For **BSA** and **ARIEL** Dealers

Service Bulletin #172

September 18, 1964

## IMPORTANT CORRECTION

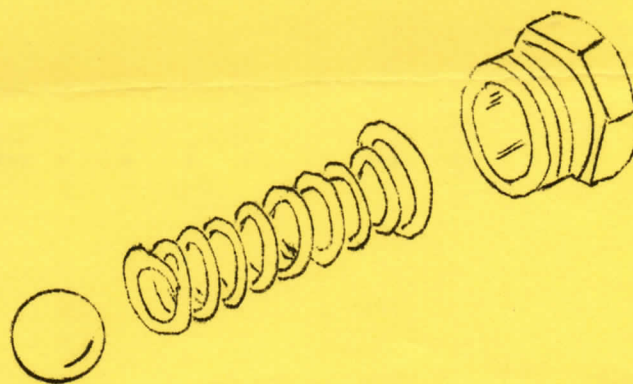
### DISREGARD SERVICE BULLETIN 169.

#### MISUNDERSTANDING IN INFORMATION SUPPLIED BY BSA FACTORY

Correct assembly of C15 - B40 Model oil pressure release valve spring shown below:

BE SURE to assemble the oil pressure release valve springs as shown below on the machines that you may have already changed around according to Service Bulletin #169.

To ensure the efficient functioning of the valve it is essential that the spring is correctly fitted, that is, with the larger diameter end seating inside the plug, as illustrated below:
